June 7, 2000

NOTE TO: Goutam Bagchi, Stu Richards, George Hubbard, John Hannon, Mark Rubin,  
Richard Emch, Jared Wermiel, Glenn Tracy, Cindy Carpenter, Faruok Eltawila

FROM: Tanya Eaton, John Lehning NRR/DSSA/SPLB

Summary of Public Comments/Staff Commitments

FIGURE 1: Envelope Ground Response Spectra for a (principal) horizontal GM direction, relating to exceedance frequencies 10<sup>-5</sup>, 10<sup>-6</sup> and 10<sup>-7</sup> annual events per site and damping ratios 0.005, 0.02, 0.05, 0.07 and 0.10.

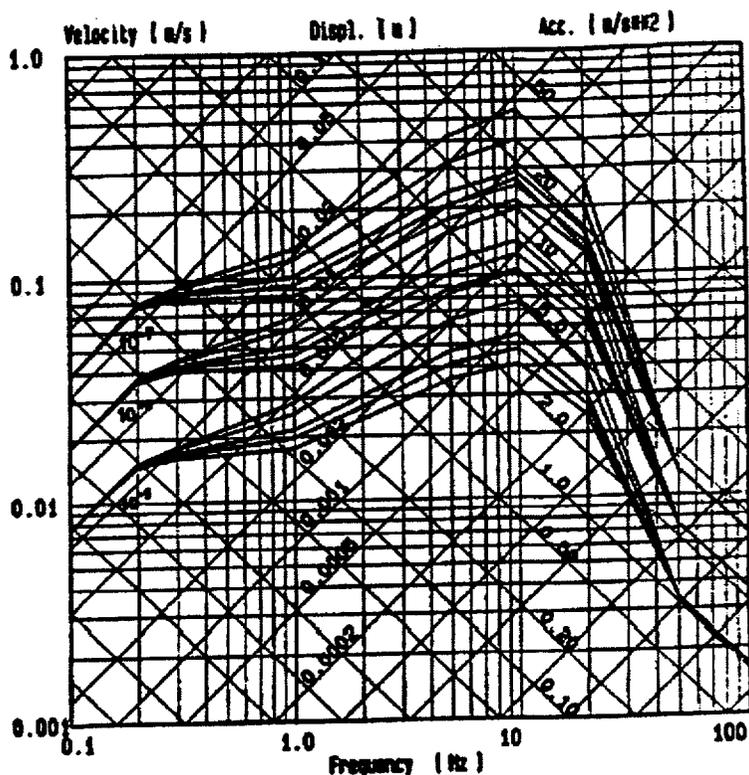
5. An US earthquake response spectra  $10^{-5}$ /year (0.5g) is considered as a  $10^{-7}$  in Sweden. Does this justify exemption from further consideration, due to low yearly frequency for Zr-fire? The SFP at the Swedish plant is calculated with an earthquake 0.1g, see response spectra Figure 1, and found to comply with the Swedish standard design standard (Boverket's Konstruktionsregler 94, BKTR 94
